Ref: SD22A/0390 - Clonbrone, Lucan-Newlands Road, Lucan, Co Dublin

"Demolition of an existing two storey detached dwelling (162sq.m) and associated out-buildings on site and the construction of 7 two storey (plus dormer level); 5 bedroom houses comprised of 3 detached houses and 4 semi-detached houses on a site area of c. 0.3ha; all associated site development works, car parking, open spaces and landscaping etc; proposed access to the development will be via the existing vehicular entrance on the Lucan-Newlands Road / Esker Hill."

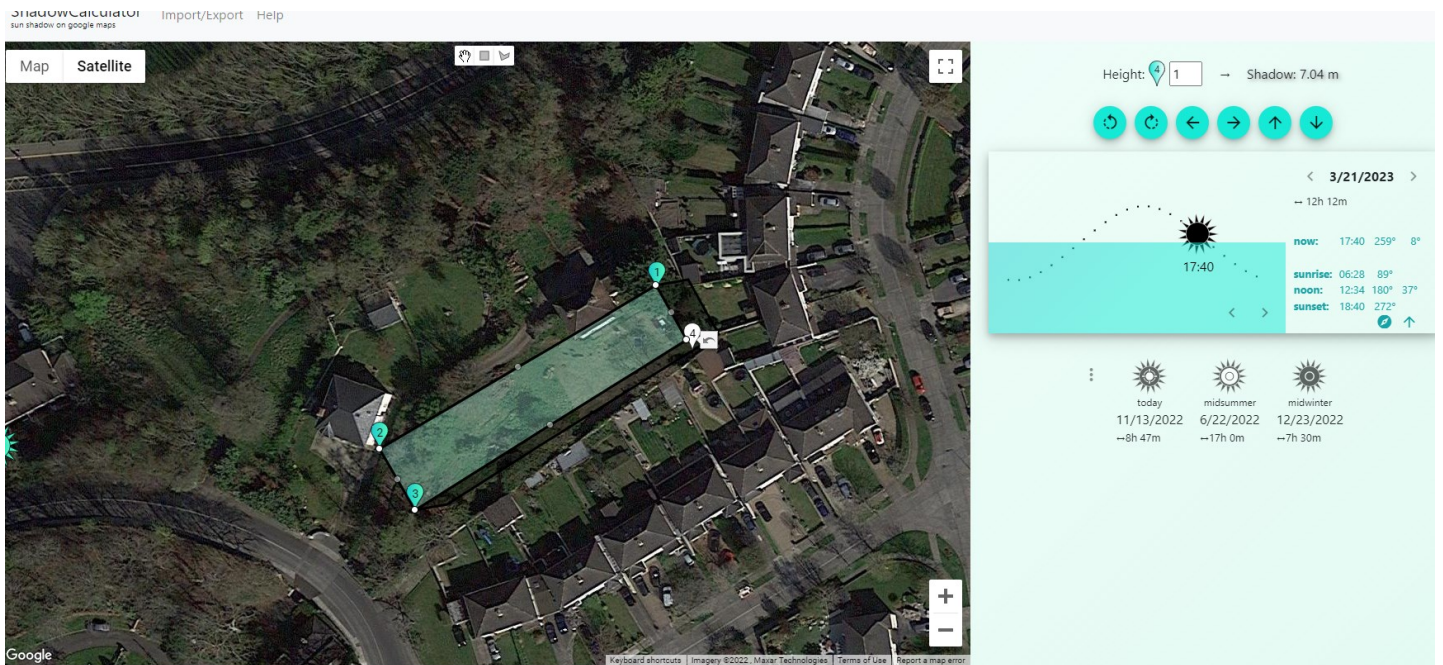
As per the rough, but reasonably indicative sunlight calculation maps included here (taken from a conservative average apex height of 9 metres), there is a clear severe impact on both side of Esker Lawns adjoining the site at various times of the year at least one hour, and possibly two, before sunset, including March 21st and its autumn equivalent (taking summer time hours into consideration).

There would also be a more specific localised impact on some of the gardens from the gable wall and roof line of houses 29-32 which need further careful examination.

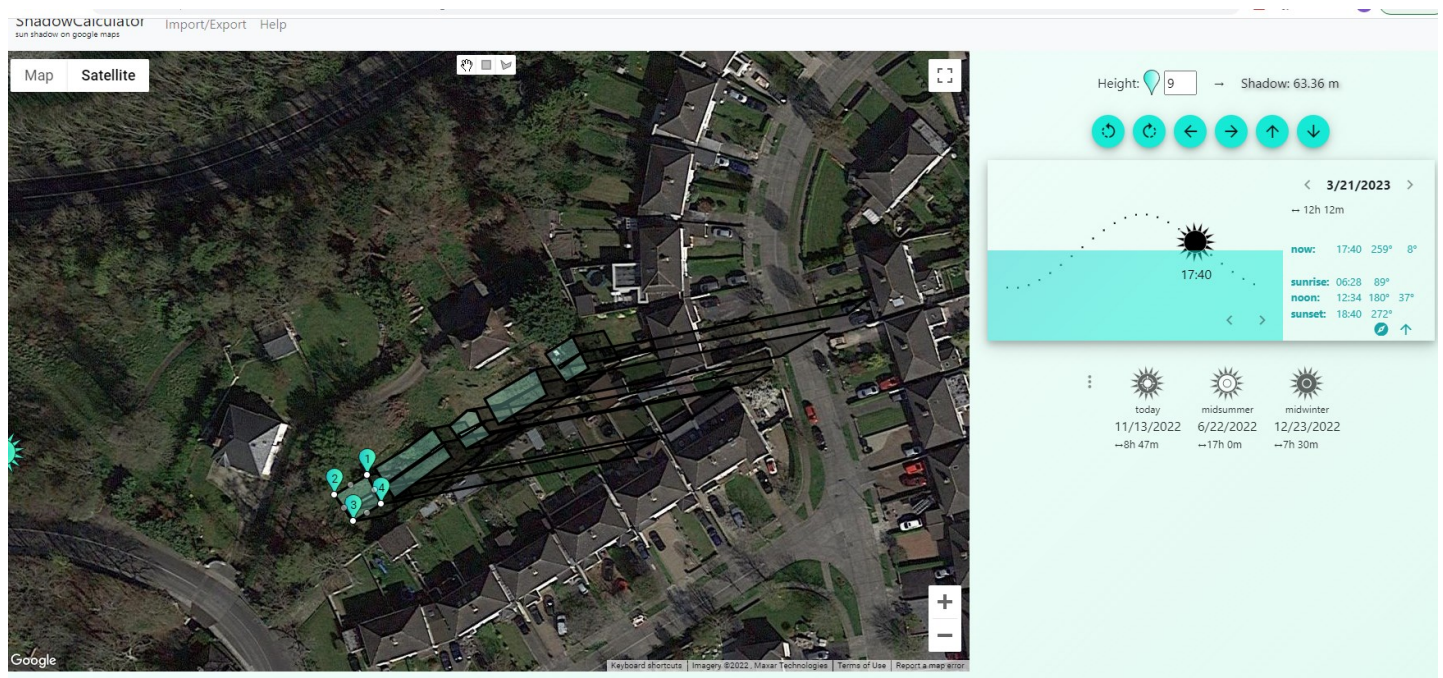
The photograph above takes a rudimentary one-metre height impact shadow assessment of the whole block area. This shows how the existing housing site area as a rule has no impact on adjoining houses.

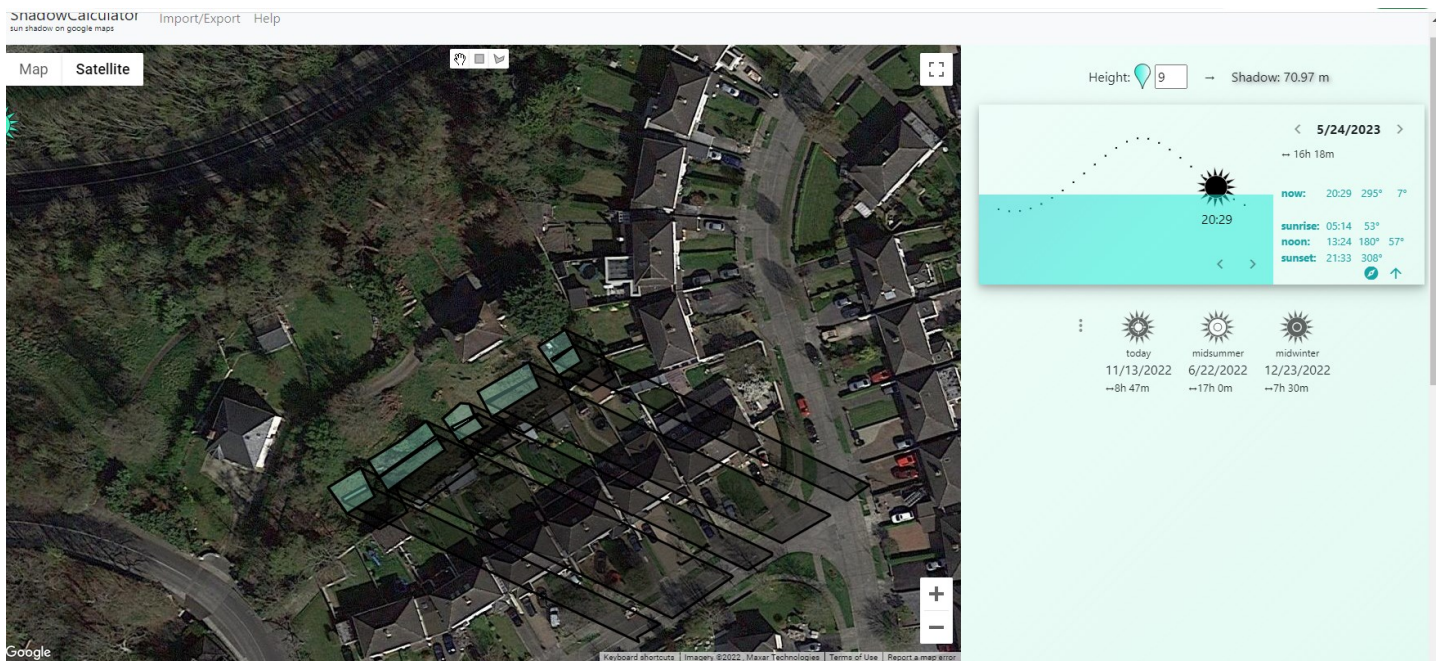
However the same cannot be said using shadow calculations for the same date an hour before sunset on March 21st. Note how the gardens of several houses are directly affected, with the shadow length sufficient to impact directly indoors in several dwellings.

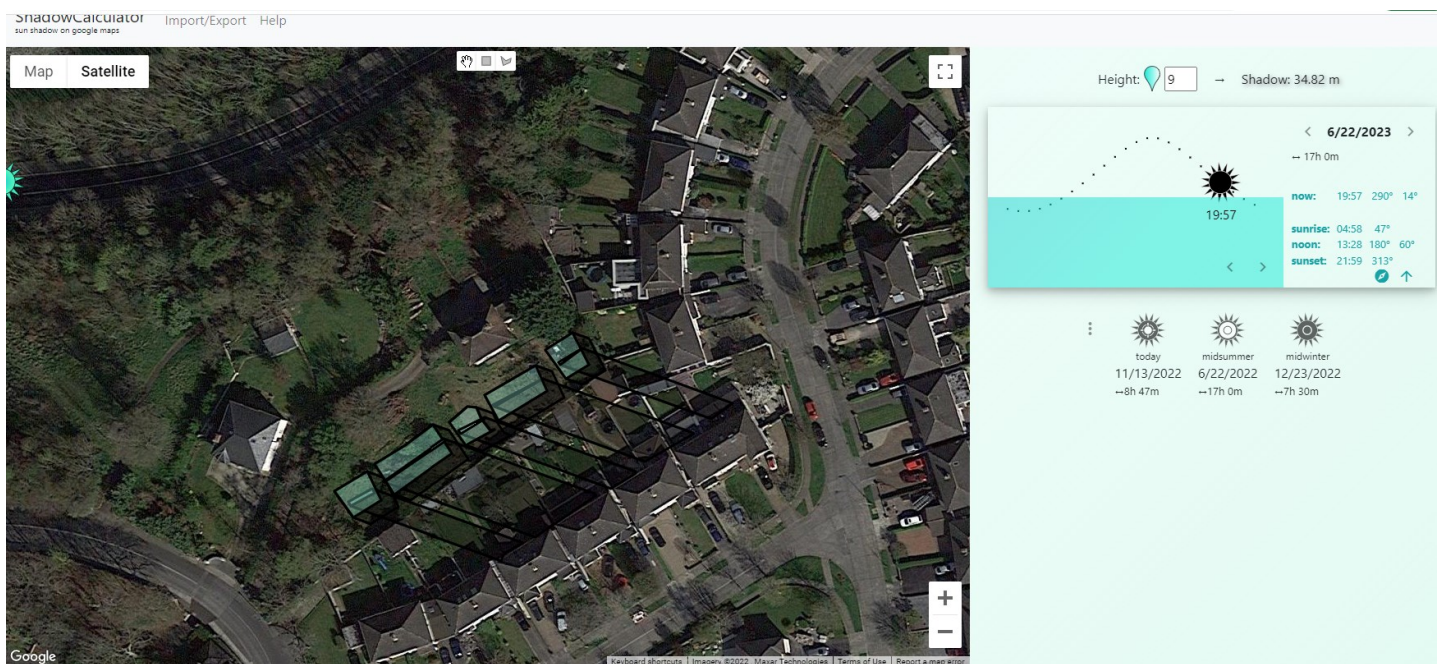
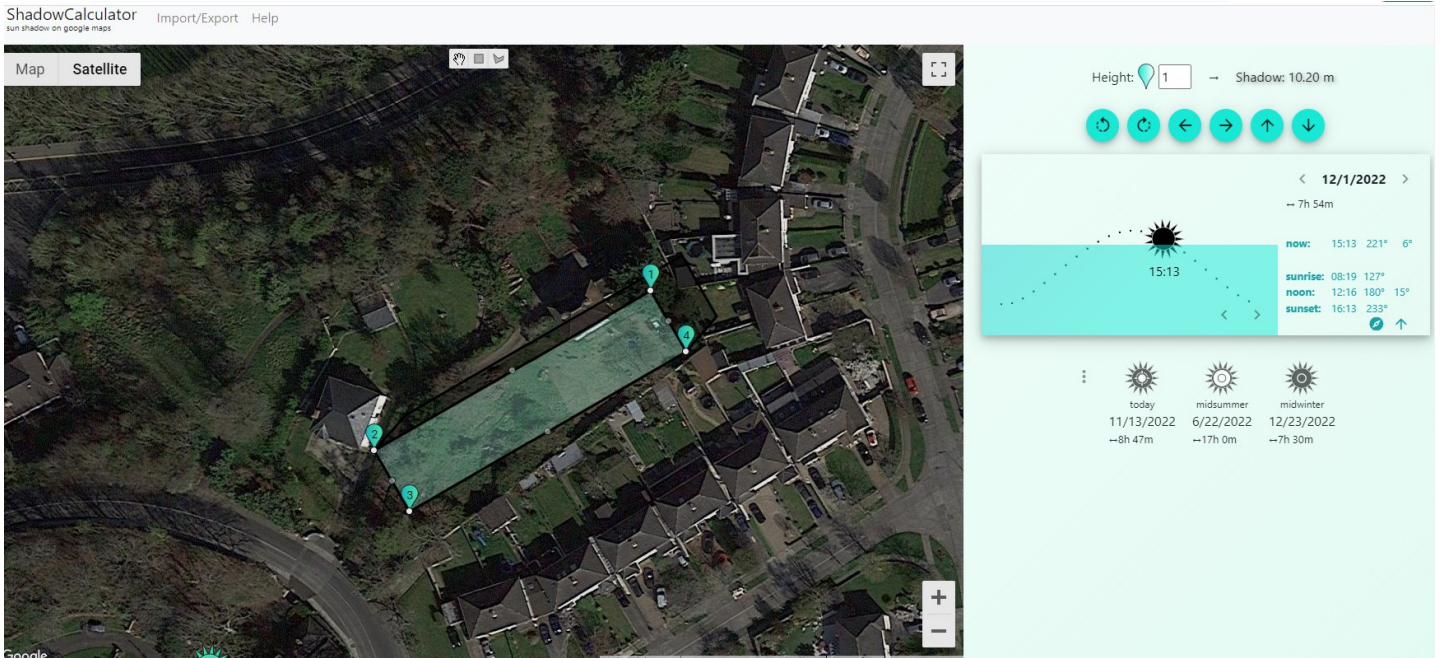
The next diagram above shows an hour before sunset on the 24th of May. At any time of year evening light is hugely important, in terms of well-being, functional use of garden space, reduced lighting costs indoors, etc. The impact at this time falls on houses to the south-east of the development. It gets worse as the setting sun tracks north-west, as shown on the 22nd June below, as indicated a full TWO HOURS before sunset:

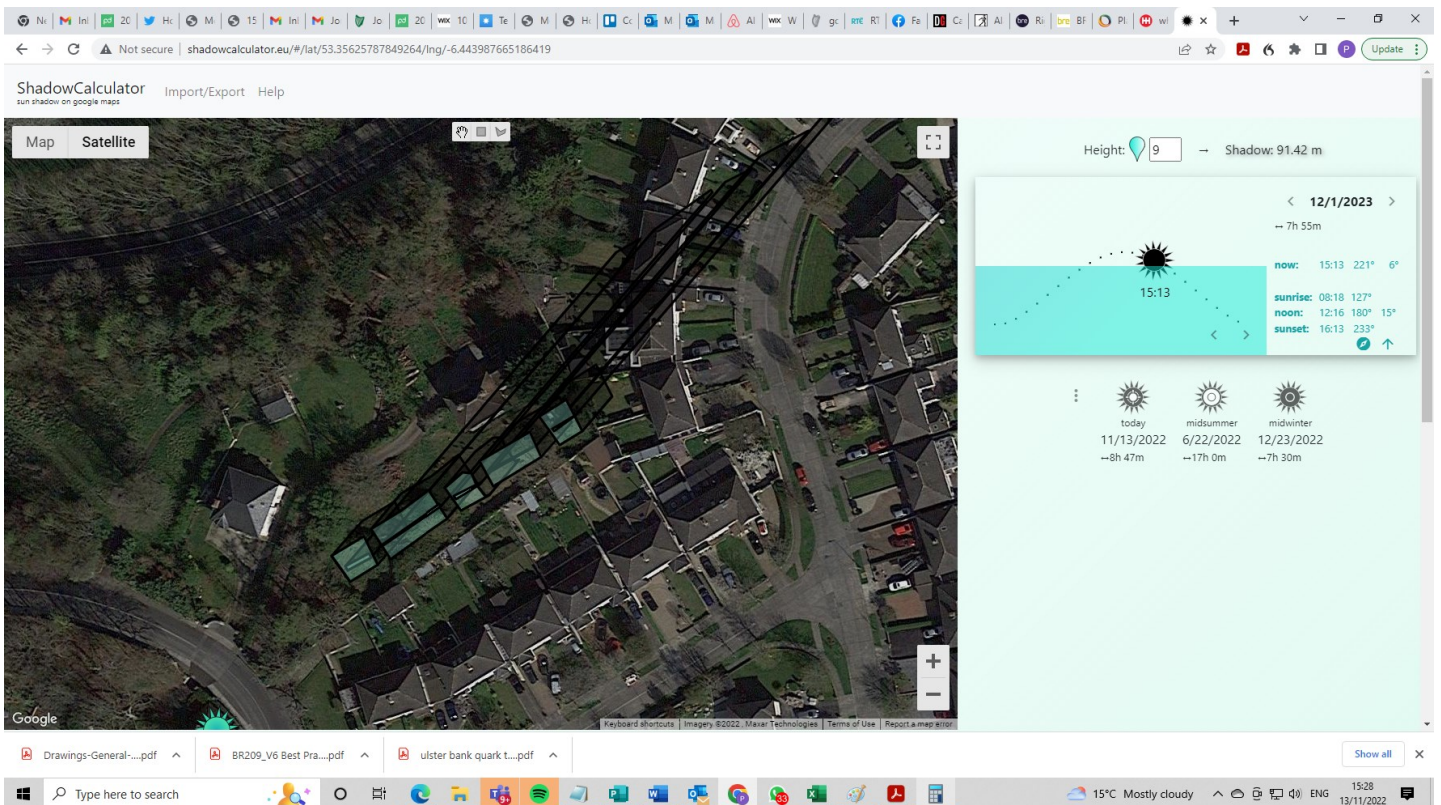
As the winter approaches the serious impact affects some other adjoining houses, to a massive degree. The rudimentary one metre height calculation of a block shown above indicates no shadow implication from the existing situation. However the shadow map below (a full hour before sunset on the sample date of December 1) shows how different this would be if the housing was permitted.

Note especially house 31 where an extension (not shown on the developer's shadowing assessment report) is clearly directly affected by shadowing. This would be not just from apex height but also from gable wall, which no doubt their own submission will highlight. No 32 is also affected detrimentally above.

Neighbours – Window Group B2

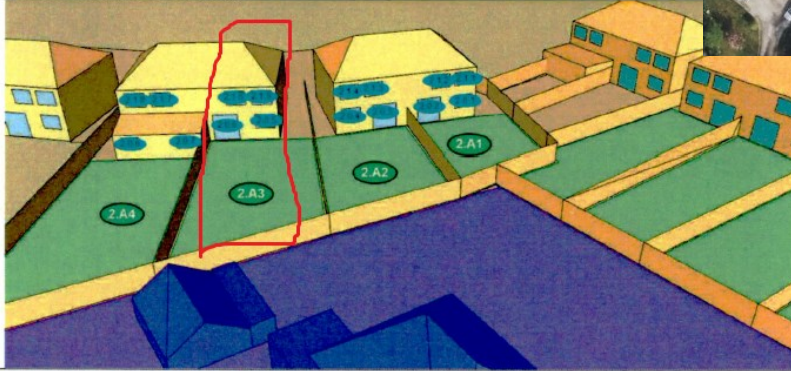
Windows facing the development

The numbering used later in this report for this group of windows is indicated in cyan above. Amenity spaces (gardens) are noted in green.

Existing Model

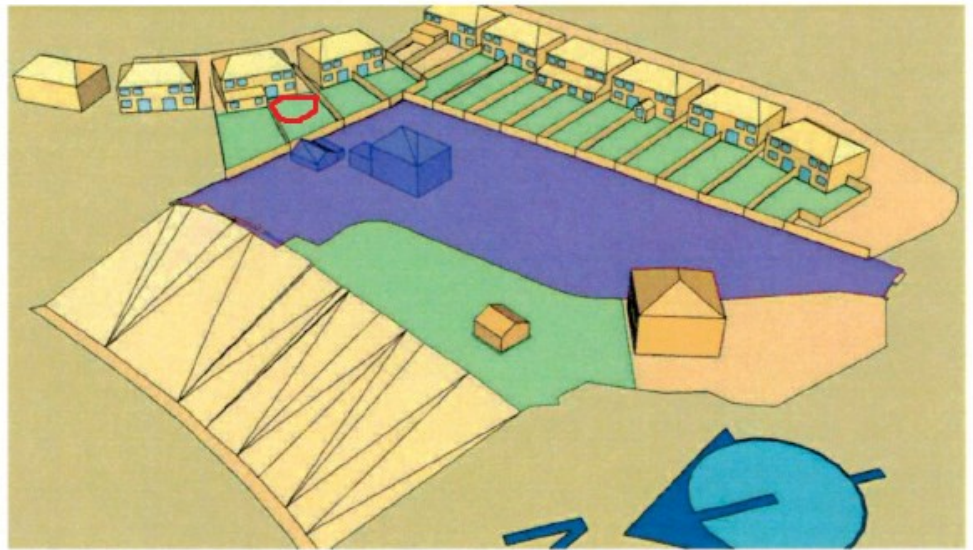
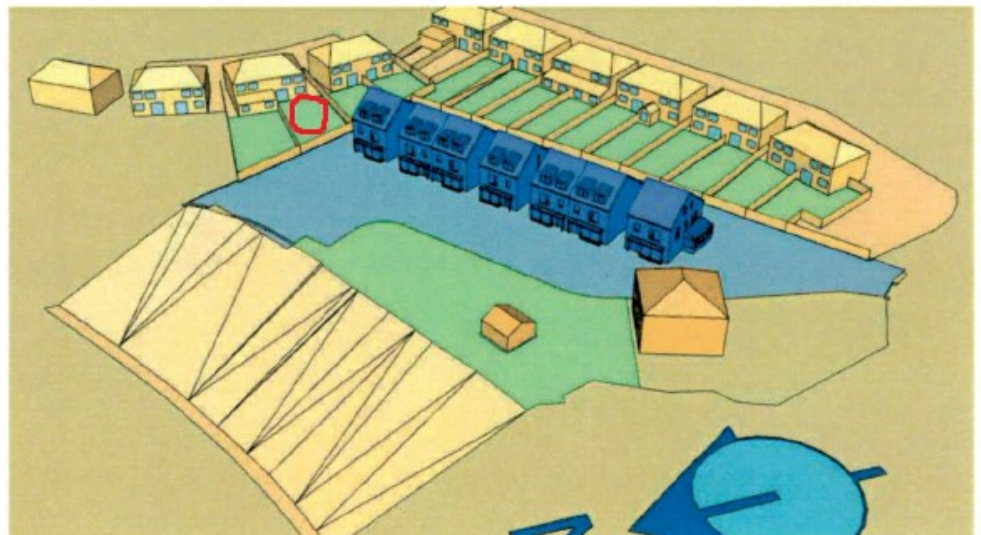
Note the area marked in red in the diagrams on this page and on the aerial map. The drawings for the developer's Sunlight, Daylight and Shadow Assessment totally omit a large single storey extension to 31 Esker Lawns, which would be impacted directly by the development

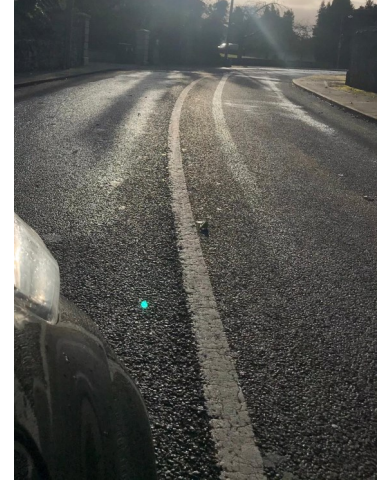
The location of a single exit on a corner is already a hazard for any vehicle exiting the existing development, but multiple vehicles at this location will significantly increase the risk of an accident. The recessing of the gate entrance may provide some additional visibility for cars exiting but the main current risk is to other vehicles and to pedestrians.

The pedestrian footpath at the location of the gate entrance is quite narrow. It continues this way down the hill and in fact gets narrower. Cars driving up the hill often have to cross close to or over the single white line so as to avoid pedestrians stepping out onto the road to pass other pedestrians, especially those with buggies or walking young children. While the correct procedure would be to slow down totally, the practice on a hill with gear changes and slowing down would be for vehicles to pass pedestrians by at normal speed, veering across the median. While such practices are not advisable they have been witnessed.
